City of Richmond

Report to Development Permit Panel

File: DP 18-829233

Re: Application by 1085948 BC Ltd for a Development Permit at 10671, 10691, and 10751 Bridgeport Road

| REVISIONS | |
|---|------------------|
| <p>SHEET TITLE</p> <p>CURVED FLASHING & FURRED EXT WALLS DETAIL (BLDG 1 & 8)</p> | |

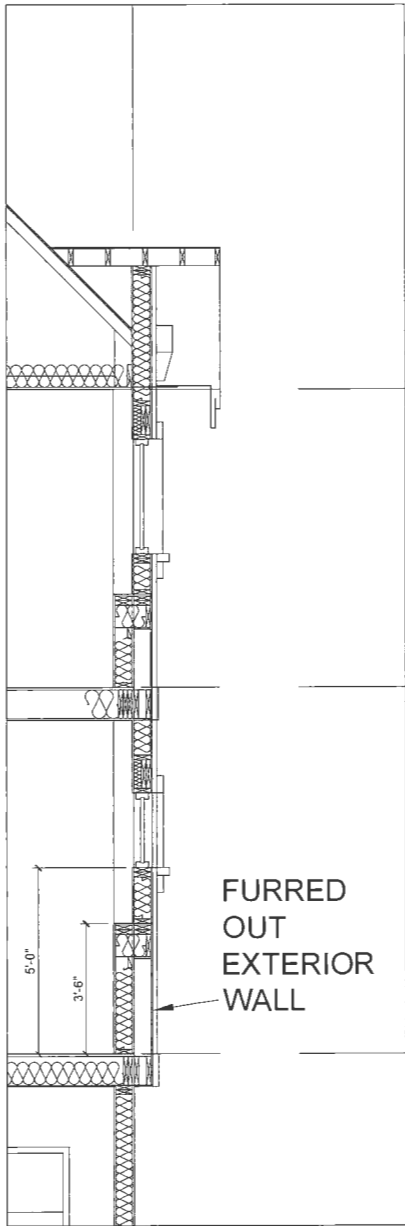
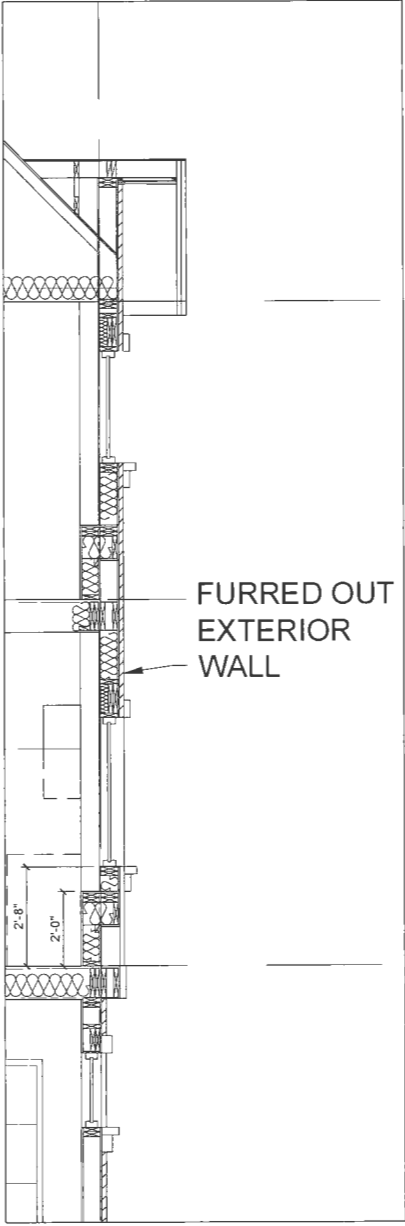
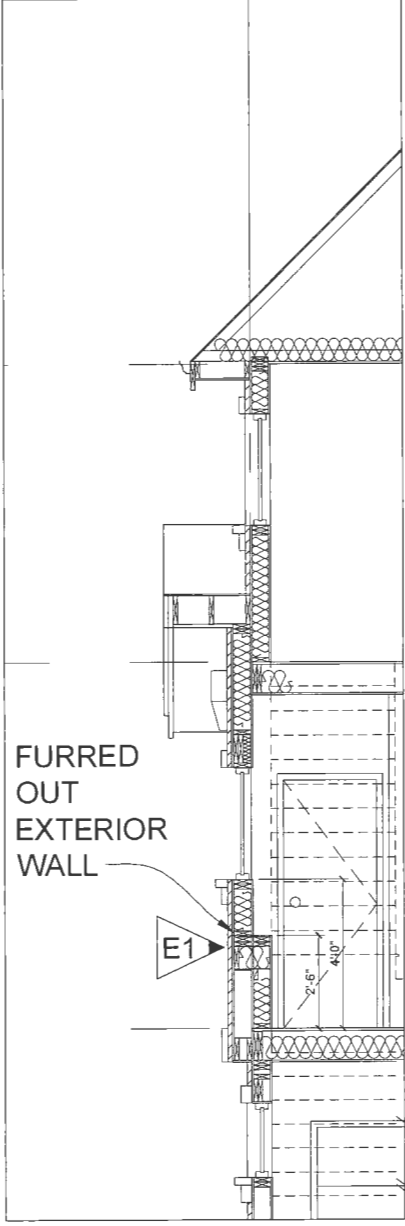
- reconsider the curved shallow furred out portions of the front facades as these appear forced and could give rise to detail issues; *The detailing of the curved furred out portions of the front facades of Buildings 1 & 8 has been revised and reviewed by the envelope engineer. The top of the furred out portions are now protected by pre-made metal flashing instead of roof shingles. Furthermore, the furred portions were made slightly thicker (from 3 ½" to 6"). The curves are an architectural device that helps unify the front façade of Buildings 1 & 8, and provides motif that is used (to a lesser extent) to create an identity to the 3 rows of buildings. The intent is for the curved flashing to be dimensioned and painted to match the exterior corner trims of the cement board cladding.*

- support the proposed curvilinear piece on the front facades which is a clever move; however, the vertical Hardie cladding furred out 3 ½ inches proud of the horizontal siding is not enough; consider adding more depth to at least 18 inches to create a more attractive building elevation and to avoid detailing issues over the long term; *Ideally, an increased depth is preferred, however the front yard setback was increased well into the project design, and limited our building depths. The detail has been finetuned, both visually and technically, and the furred out portions were made slightly thicker (from 3 ½" to 6").*

INTERIM CONCEPT ROAD PLAN (NOT FOR CONSTRUCTION; FINAL DESIGN TO BE DETERMINED THROUGH SA)

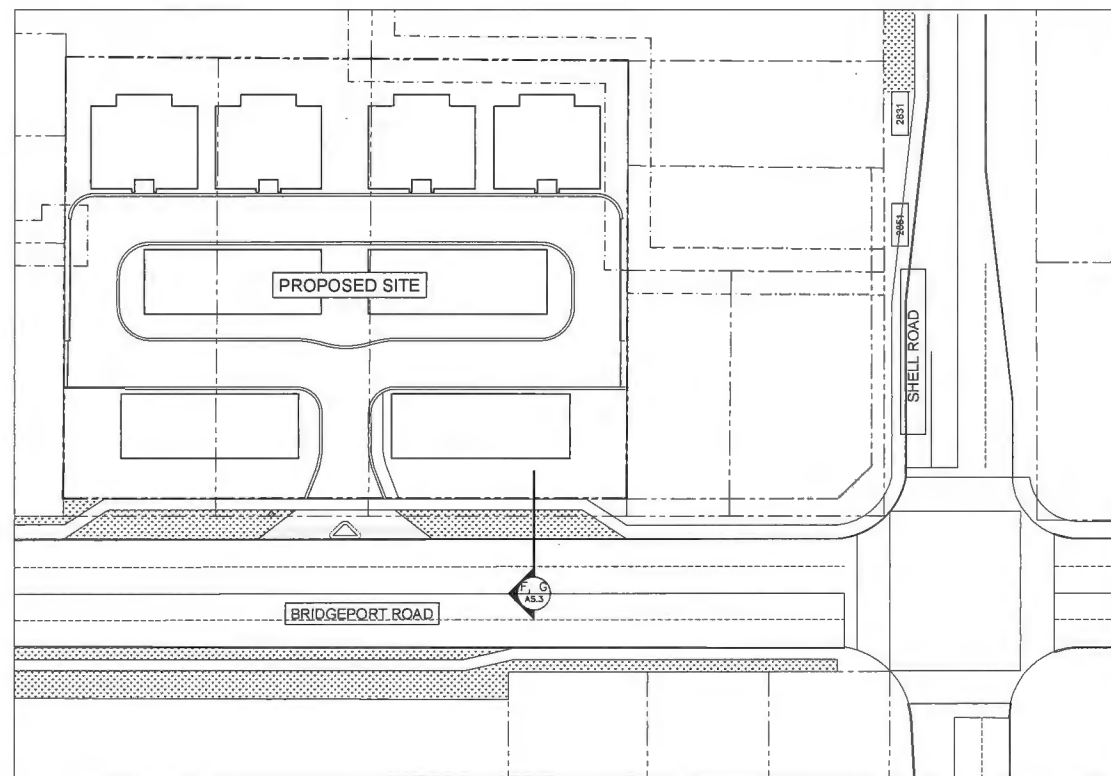
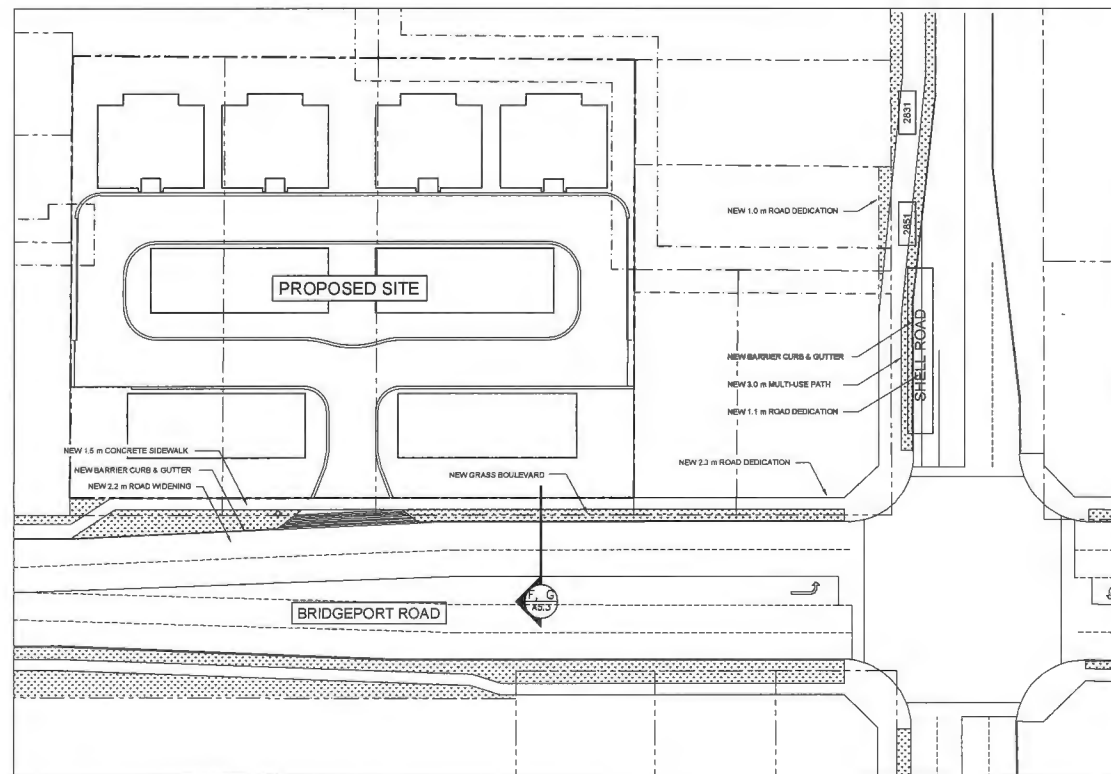
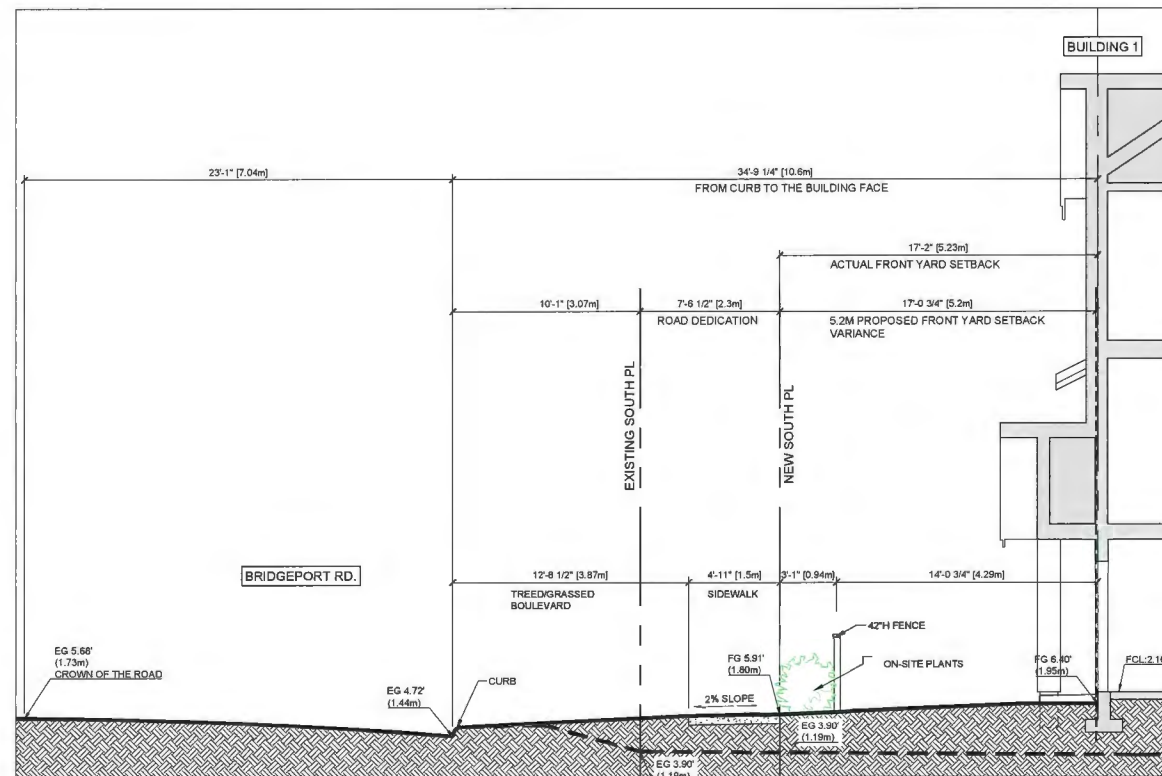
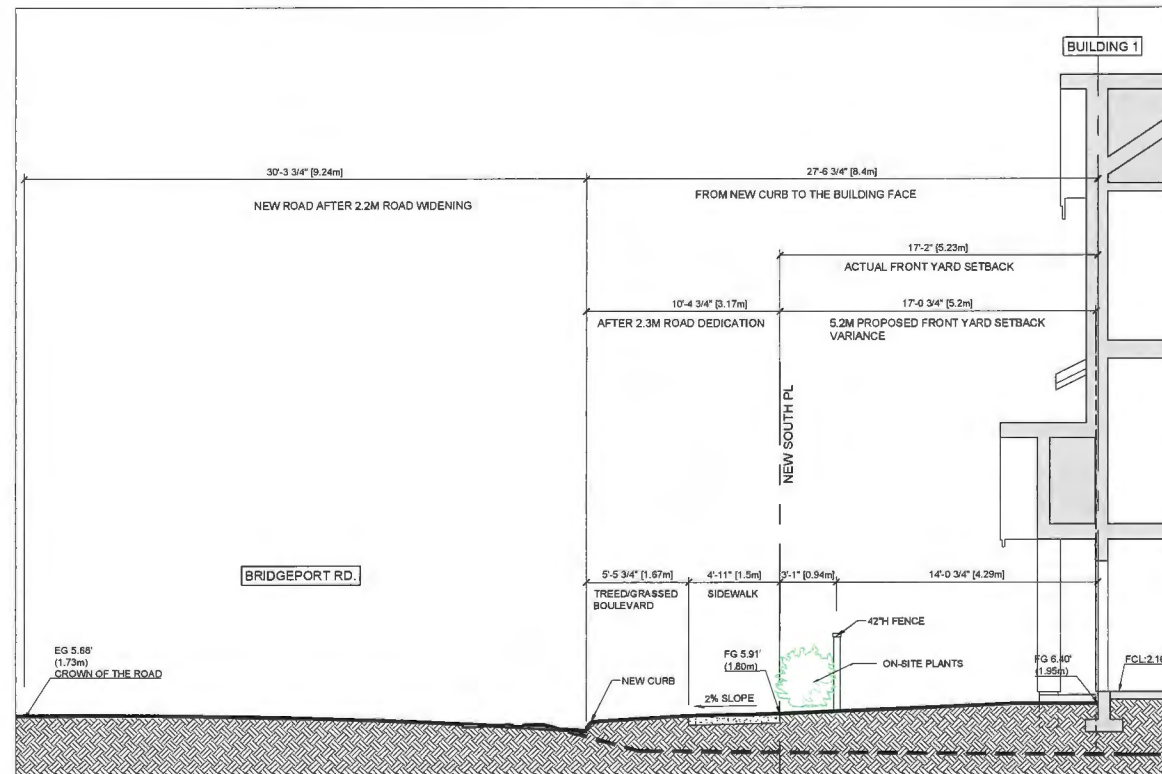
- Since the design of the off-site boulevard treatment is being reviewed as part of the SA process, an interim concept is shown on the architectural and landscape plans.

7
L1
TRELLIS STRUCTURE AT AMENITY AREA
SCALE: 1/2" = 1'-0"

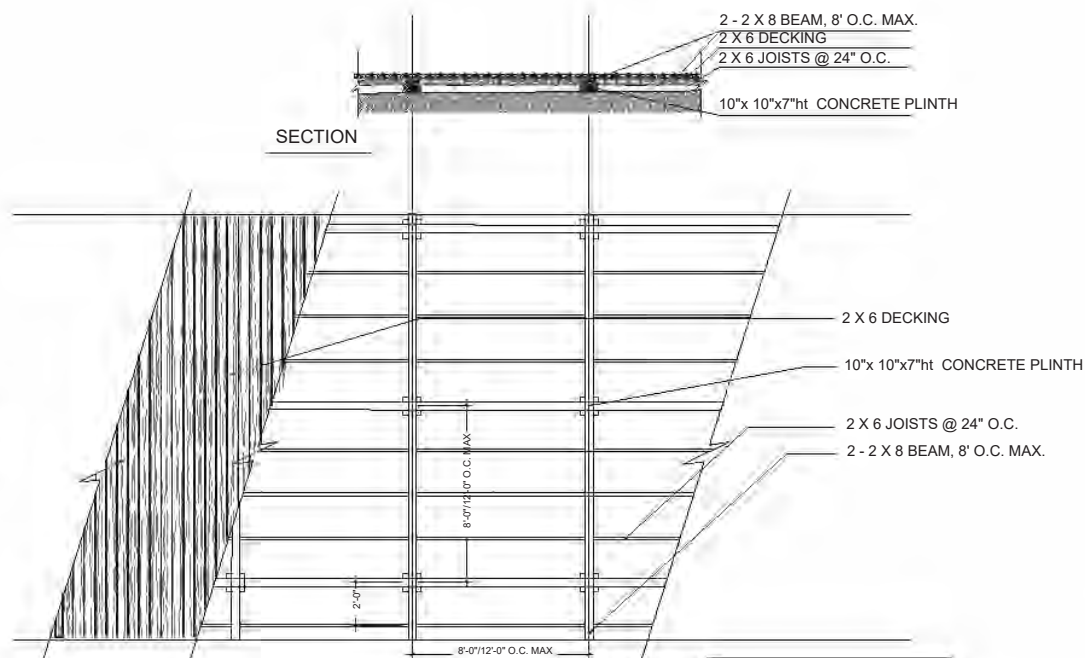
- consider installing a special landscape feature at the north entrance to the north-south pedestrian walkway to identify it as a public entry for residents in the immediate neighbourhood; *Added wood trellis feature as a visual terminus just clear of the sewer right-of-way (until the public pathway is eventually opened up to the north properties), which is both a practical and visual improvement in the north amenity area (i.e., more centrally positioned as a hard landscape element to be experienced from both sides).*
